1 << NOTE FROM BOB SULTAN: This document supplies additional text and modified figures for portions of
2 802.1Qbg subclause 41.1.8 for the resolution of comment #738 ([http://www.ieee802.org/1/files/private/bg-](http://www.ieee802.org/1/files/private/bg-drafts/d1/802-1Qbg-D1-3-dis-v1.pdf)
3 [drafts/d1/802-1Qbg-D1-3-dis-v1.pdf](http://www.ieee802.org/1/files/public/docs2011/bg-gu-pcp-in-vdp-rsp-0111-v02.ppt)). This material is also described in the slides [http://www.ieee802.org/1/](http://www.ieee802.org/1/files/public/docs2011/bg-gu-pcp-in-vdp-rsp-0111-v02.ppt)
4 files/public/docs2011/bg-gu-pcp-in-vdp-rsp-0111-v02.ppt presented at the January 2011 interim meeting.
5 Features added are:

34 35 **41.1.8 Filter Info field**

Figure 41-2—VID Filter Info format

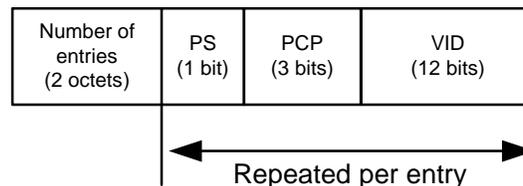
- 6 1) A Priority Code Point (PCP) value can accompany any, or all, VID values specified in a VDP
7 Response;
- 8 2) The 2-octet field of the VDP TLV that was called the VID field is no longer called the VID
9 field and is replaced by a 1-bit PCP Significant (PS) field, a 3-bit PCP field, and a 12-bit VID
10 field;

<< Note that in the following subclauses *only* the figures 41-2 through 41-5 have been modified. No text has been modified (as indicated by the change bars).>>
